Title → Minutes - Community Reference Group Meeting 2
 Purpose → CRG to make recommendations to the project team
 Date → 1/12/2021
 Location → Online – Zoom

Community Reference Group – Fitzroy North, Meeting 2

5-6pm, 1 December 2021

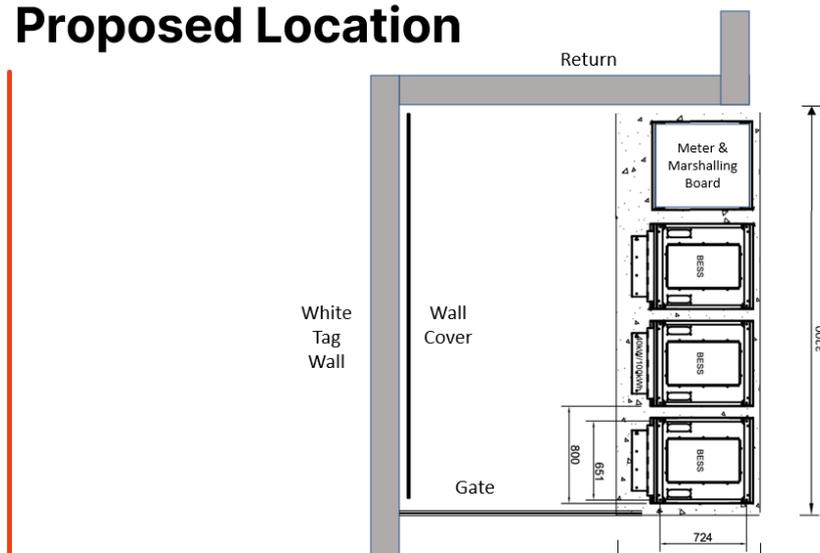
CF: Still concerned about people getting over the gate at that height, and getting into mischief behind. Did some measurements last weekend along Michael Street (along the 'black tagged wall'). Quite like what is proposed here, but still concerned that people can still get over gates and walls.

RE: Looks good where you've drawn it. Have had discussions with others in the street, they are most worried about noise. The data suggests that's not likely to be a concern. Many of us have bedrooms facing the site and were concerned about the disturbance from noise.

JC: Why not a wire mesh cage over the top (rather than barbed wire as a solution). Noted it could be a lid on top as well.

CF: Where the return wall comes, will the batteries be flush with that or jut out?

CRG endorsed the location, placement and position of the battery unit on a concrete slab as per the drawings/design CW presented (see final slide of the Powerpoint presentation). This also includes the expectation that YEF will:

1. Discuss with the installer their recommendations for a possible ‘lid’ (could be wire mesh or other optimal solution) to deter/prevent people climbing over the units, and
2. Discuss the need for CCTV, although the CRG didn’t think it was critical as the area has relatively busy traffic and is relatively well lit.
3. Review and decide on best options to install some acoustic treatment (this could be acoustic panels or vegetation etc. and is yet to be decided based on further professional advice) to minimise even further the noise from the battery units.
